This Service Information bulletin supersedes S.I. M64 02 04 **dated August 2004.**

SUBJECT**A/C Does Not Blow Cold Air****MODEL****NEW** R50 (Cooper) with CVT (Automatic Transmission)

Vehicles produced up to August 18, 2004

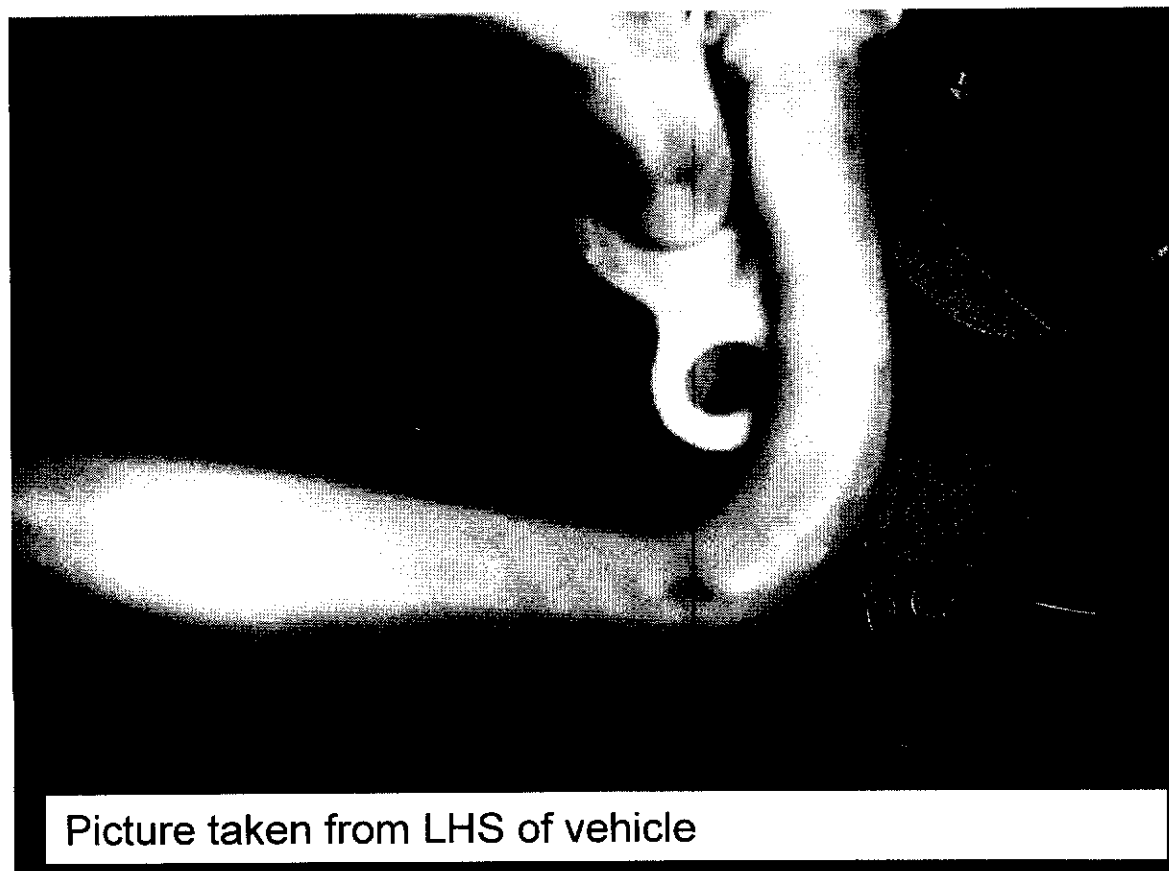
The A/C line from the condenser to the evaporator is cut by a sharp edge on the CVT oil pan.

1. **NEW** If the vehicle was produced prior to August 18, 2004 proceed to the next step. For vehicles after the above mentioned production date, before disturbing the routing of the cut hose, take digital pictures from the angles as shown in the attachment, and attach them to a PuMA case.
2. Replace the hose and reposition it so that it does not rub on the oil pan. Refer to Repair Instruction RA64 50 009 (Drawing off, evacuating and filling A/C system – R134a).
